Our Ref: KC2225/MS

17<sup>th</sup> December 2021

**Proposed Development of Curraghinalt Mine  
Response to NIEA letter of 18<sup>th</sup> November 2021; Ref: TC80/20, AIL/2020/0105, AIL/2020/0106**

**Figure 1: Stages of Water Balance Test**

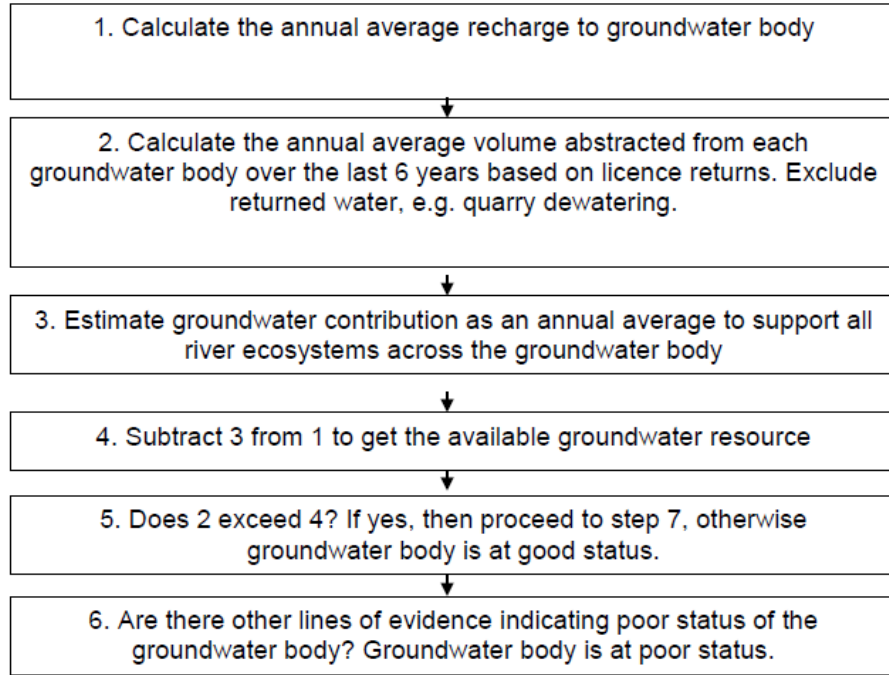
The NIEA letter specifically asks for '*supporting information to verify whether the proposed abstraction will impact the status of the groundwater body based on the water balance test*'.

The methodology for the Water Balance Test is outlined in '*River Basin Management Plans (2015 – 2021): Groundwater Classification Methodology Water Balance, December 2015*' published by the Northern Ireland Environment Agency (the 2015 NIEA Methodology). Figure 1 below describes the stages identified in the 2015 NIEA Methodology.

UKTAG guidance (para 4.4) states that *'Abstracted groundwater that has been locally returned to the aquifer or to a river should be discounted (for example, this may occur at a quarry/mine dewatering operation'*. The specific reference to mine dewatering is noted. This guidance is reinforced in the 2015 NIEA Methodology and Figure 1, where abstracted water that is returned (e.g., quarry dewatering) is excluded from the calculation.

Therefore, following UKTAG and NIEA guidance the proposed abstractions are excluded from the Water Balance Test. As a result, given that the abstracted volume from the Gortin groundwater body would not be increased within the Water Balance Test calculation (Step 2 in Figure 1), there will be no impact on the status of the Gortin groundwater body as a result of the Water Balance Test.
